**SECTION 16 APPLICATION
TOWN PLANNING ORDINANCE (CHAPTER 131)**

**PROPOSED SOCIAL WELFARE FACILITY (RESIDENTIAL CARE HOME FOR THE ELDERLY) IN
“VILLAGE TYPE DEVELOPMENT” ZONE ON APPROVED NAM SANG WAI OUTLINE ZONING
PLAN NO. S/YL-NSW/10 AT LOTS 3670 RP (PART), 3671 RP (PART), 3672 RP (PART) AND 3673
RP (PART) IN D.D.104, NAM SANG WAI, YUEN LONG**

Town Planning Application No. A/YL-NSW/349 - Submission of Further Information (2)

PROPOSED SOCIAL WELFARE FACILITY (RESIDENTIAL CARE HOME FOR THE ELDERLY) IN “VILLAGE TYPE DEVELOPMENT” ZONE ON APPROVED NAM SANG WAI OUTLINE ZONING PLAN NO. S/YL-NSW/10 AT LOTS 3670 RP (PART), 3671 RP (PART), 3672 RP (PART) AND 3673 RP (PART) IN D.D.104, NAM SANG WAI, YUEN LONG
(Planning Application No. A/YL-NSW/349)
Response-to-Comment Table

**FIGURE 2.1
LOCATION OF REPRESENTATIVE AIR
SENSITIVE RECEIVERS**

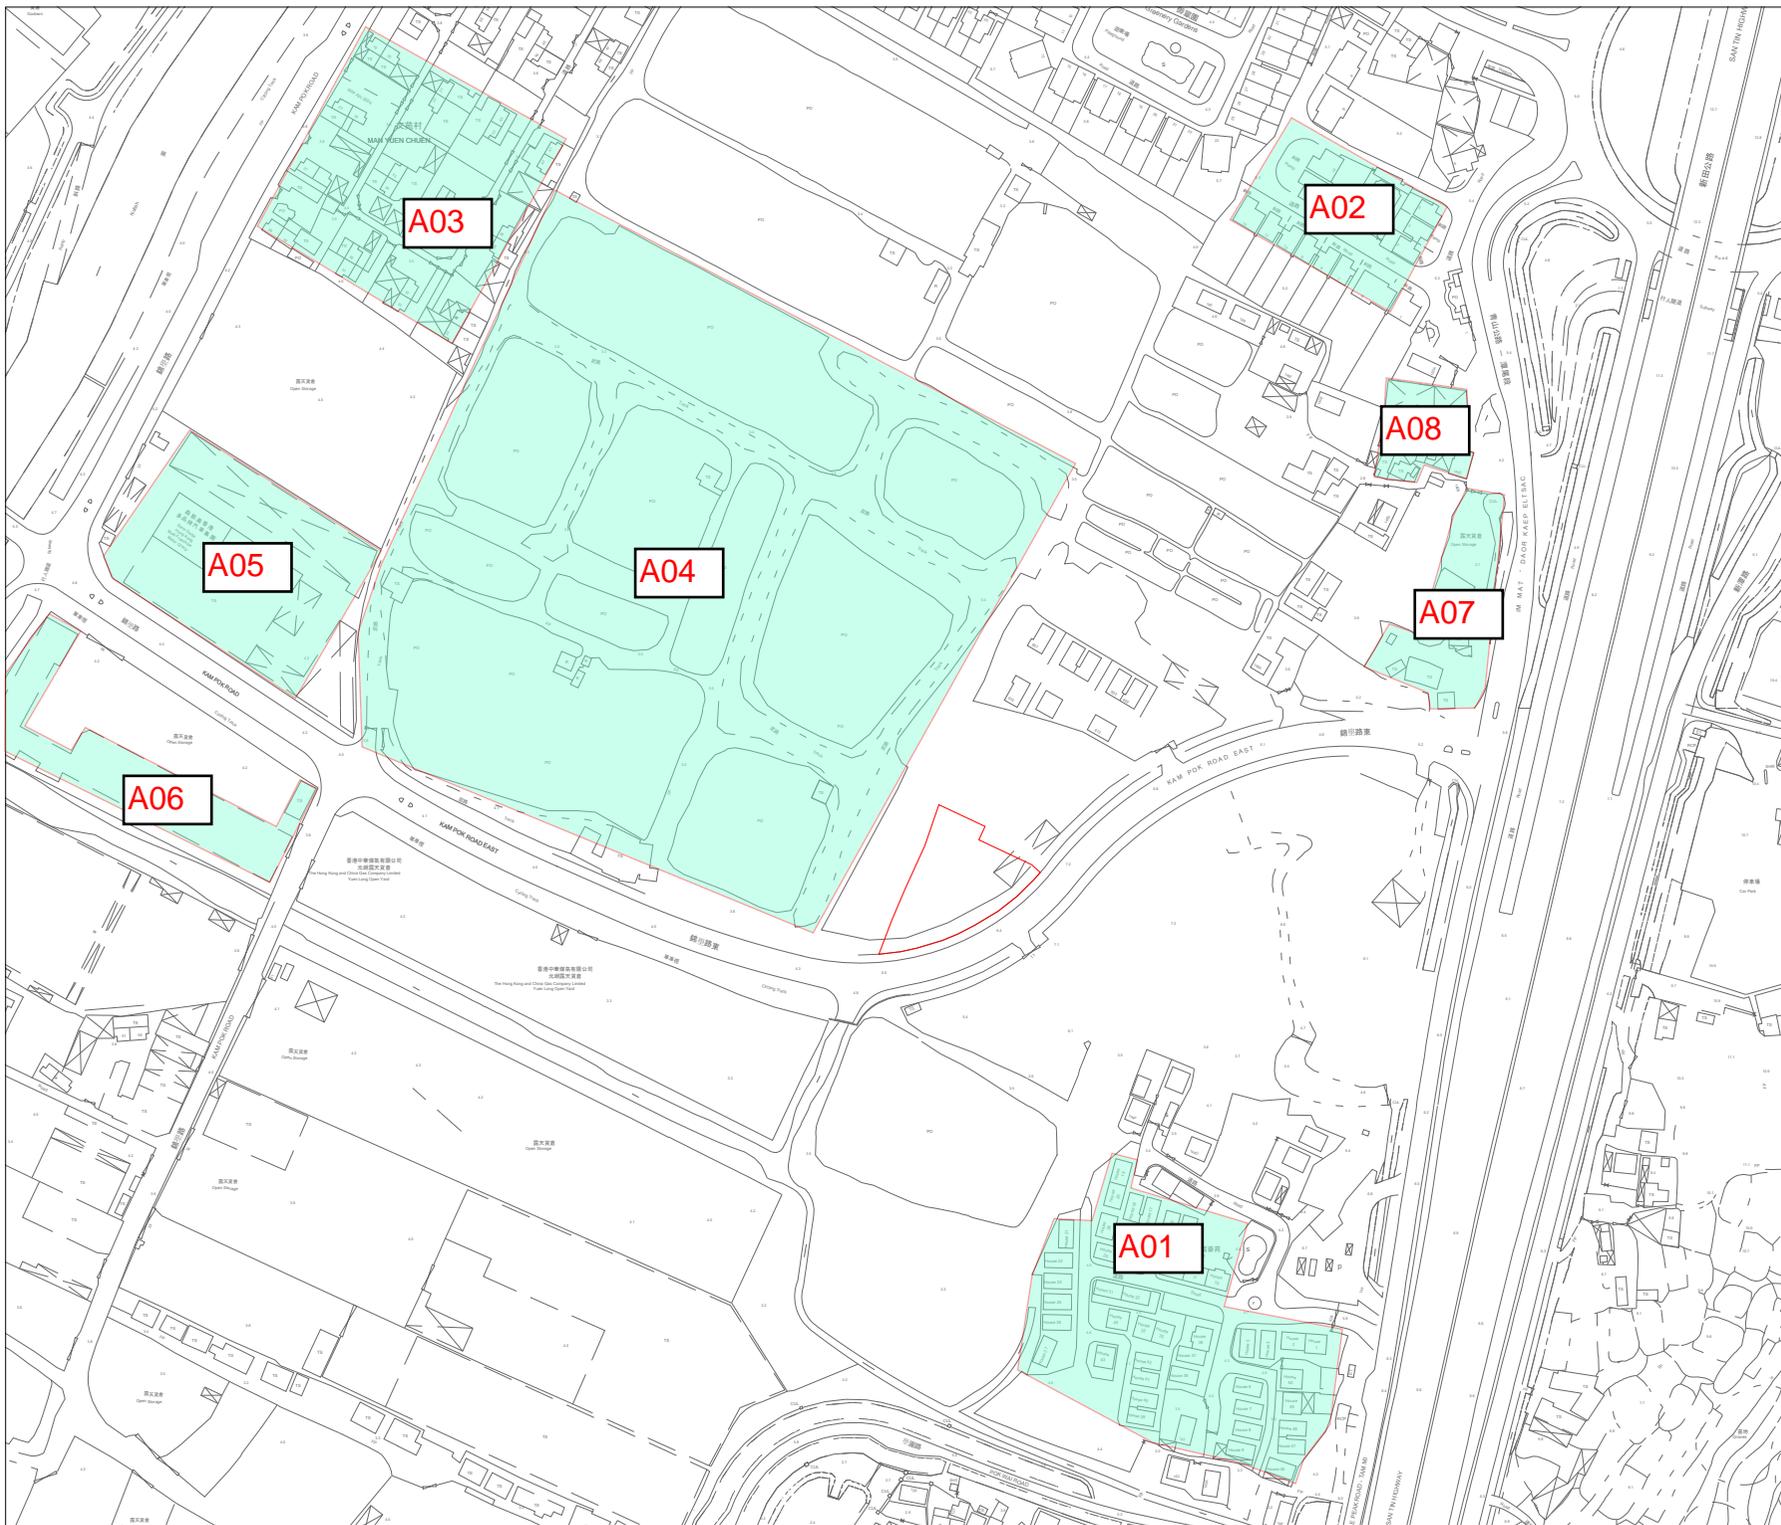
3. Section 2.3.1, Table 2.3 and Figure 2.1 - Please note that not only the domestic premises are the ASRs, some places/premises such as factory and workshop may also be the ASRs. Based on the desktop review, there are some areas in the vicinity of the project site which have been used for workshops/open storage, etc. Please review the potential existing/planned ASRs within the assessment area with reference to the Determination of ASR under the EIAO-TM and update as appropriate.	More ASRs have been identified in Table 2.3 and Figure 2.1. For other areas mainly for open storage use where long duration of exposure to air pollutants is not expected are, therefore, not considered as ASR. Please refer to the revised EA (Appendix 1).

**FIGURE 3.3
LOCATION OF PROPOSED ACOUSTIC
WINDOW**

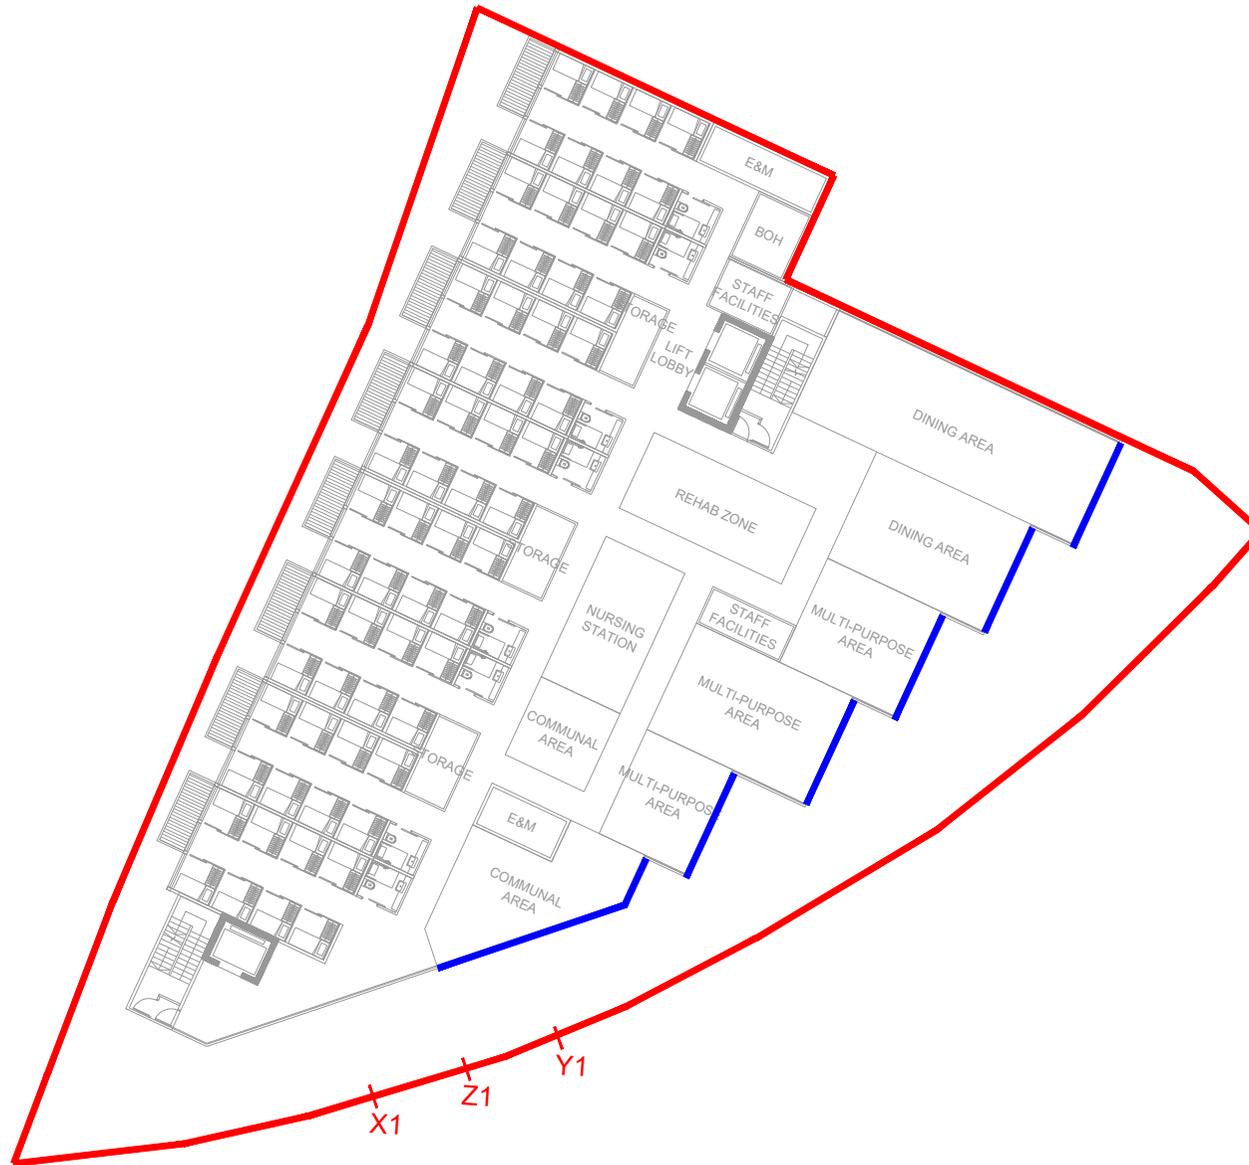
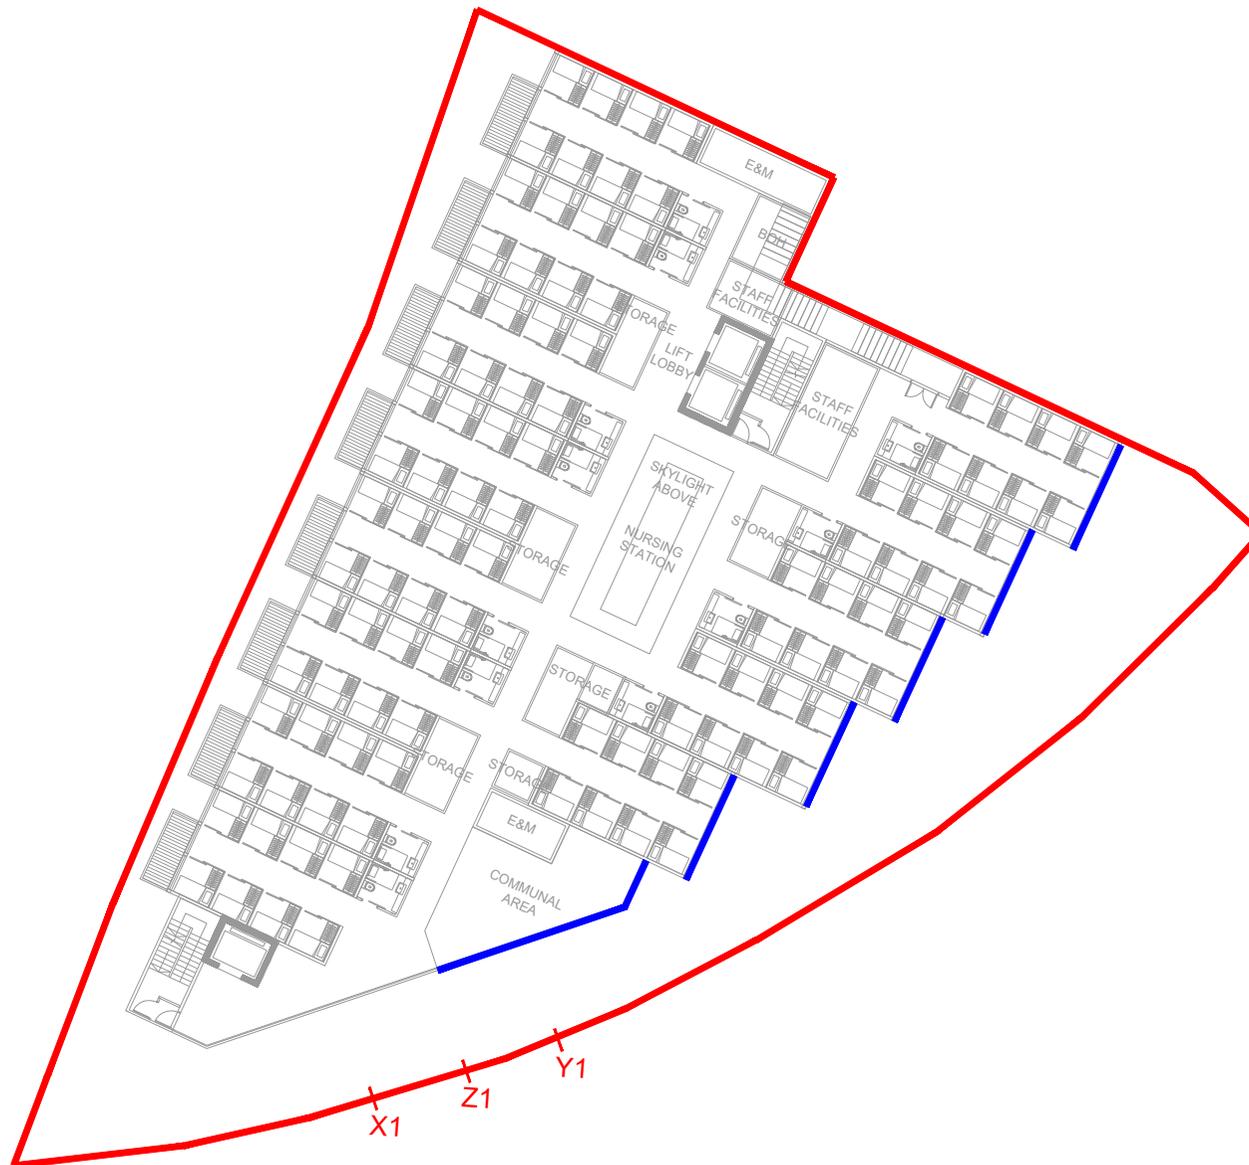
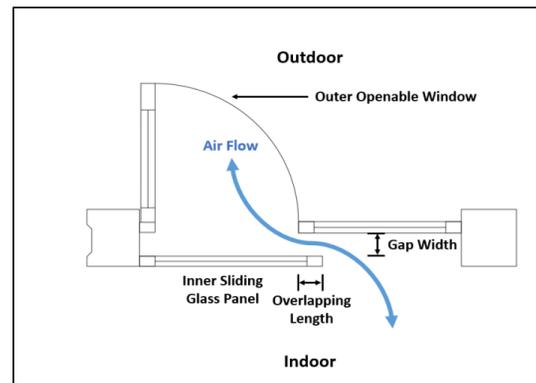
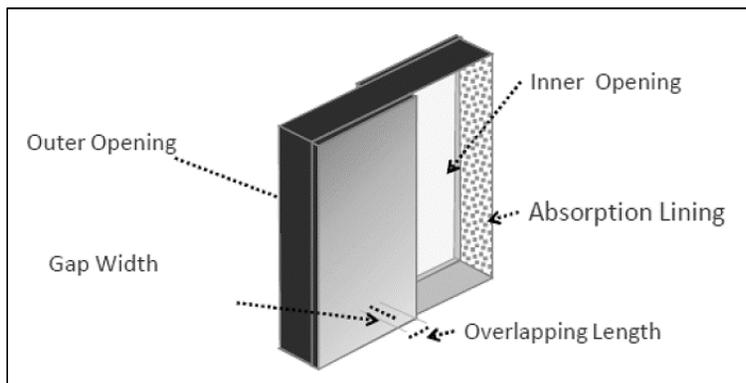
<p>9. S.3.4.12 and Fig.3.3, Appendix 3.2 i. As shown on Fig 3.3, the reference case for Type 2 AW(BT) is under room size of 18 m² with a specified window design, providing a noise attenuation of 7 dB(A). S.3.4.12 also suggests that noise reduction depends on room size. While Appendix 3.2 proposes the use of Type 2 AW(BT) at 21 NAPs, please provide the room size in the tentative layout and any room size correction, justifying a noise attenuation of 7 dB(A) by Type 2 AW(BT) are appropriate.</p>	<p>Please be clarified that the room size of dormitory is typically 40 to 50 m², which is larger than 18 m², therefore, no room size correction is included for conservative approach. Please refer to the revised EA (Appendix 1).</p>
<p>10. S.3.4.16 i. In order to provide a guidance for future development, please supplement the prevailing background noise levels with full details of the prevailing background noise measurement, including personnel, equipment, weather, field observations, etc., shall be documented and included in the report for easy future reference.</p>	<p>Discussion of prevailing background noise measurement is added in Section 3.4.16. Please refer to the revised EA (Appendix 1).</p>

FIGURE 3.4
LOCATION OF BACKGROUND NOISE
MEASUREMENT AND MAJOR FIXED NOISE
SOURCES

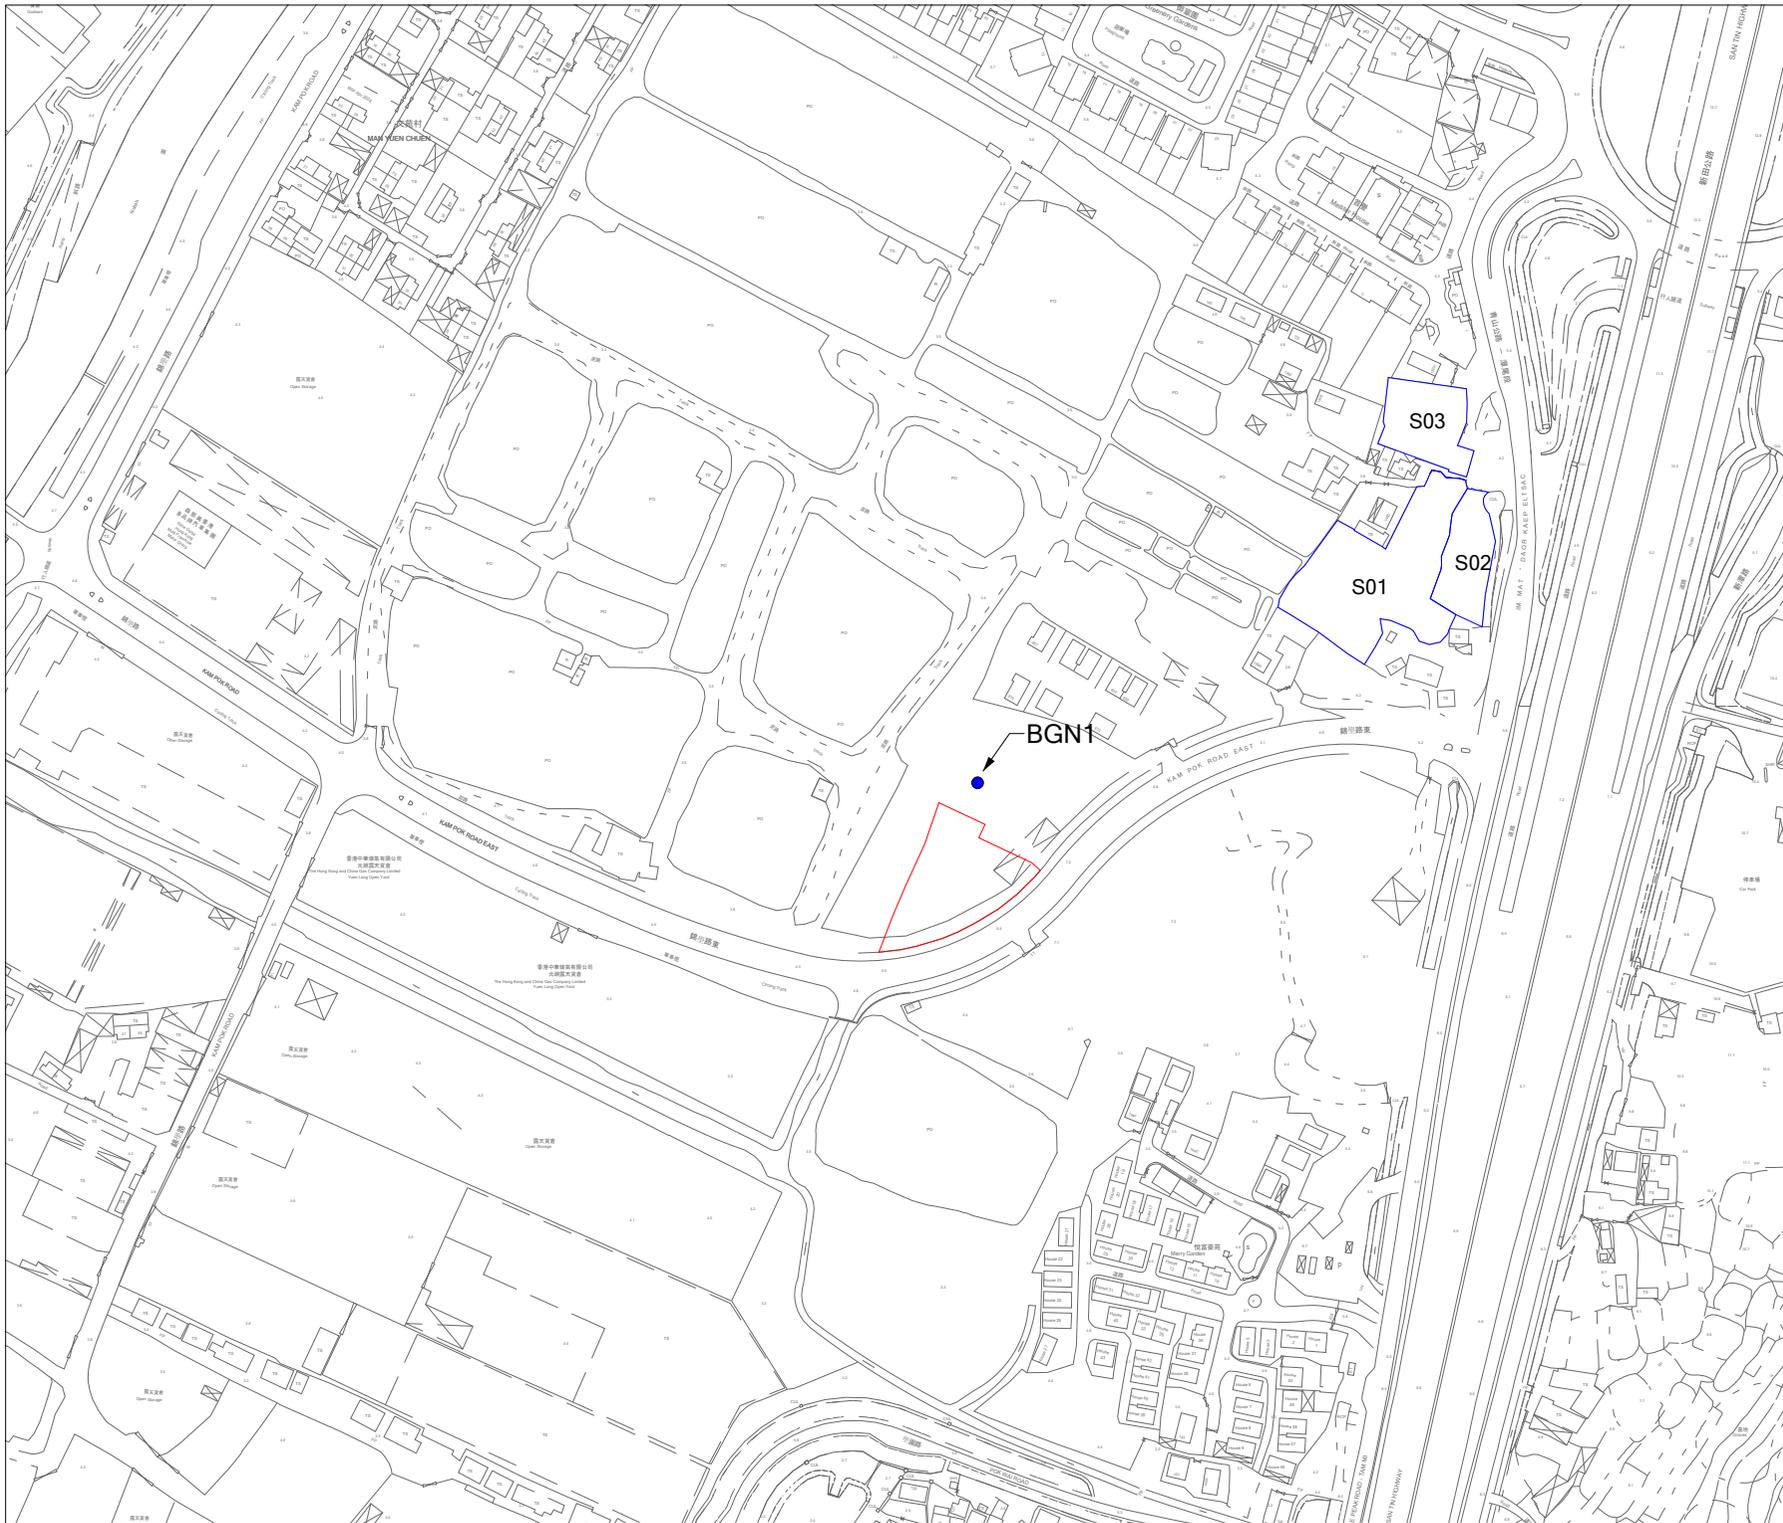
<p>11. S.3.4.18 and Table 3.7 i. Figure 3.3 is Location of Proposed Acoustic Window. Please update and provide the corresponding figure indicating the location of existing major noise sources. Please also attach the site inspection report with photo of the open storage in site visit. ii. The location of S01 is currently unknown, but it is reported to be approximately 100 meters away from the project site. If there are no building separations between S01 and the proposed site, we recommend conducting sound measurements and providing calculations for a noise assessment. This will help to demonstrate that open storage will not negatively impact the proposed site.</p>	<p>Location of existing major noise sources and site inspection record are presented in Figure 3.4 and Appendix 3.3 respectively. Please refer to the revised EA (Appendix 1).</p> <p>Sound measurements are presented in Appendix 3.3. Please refer to the revised EA (Appendix 1).</p>
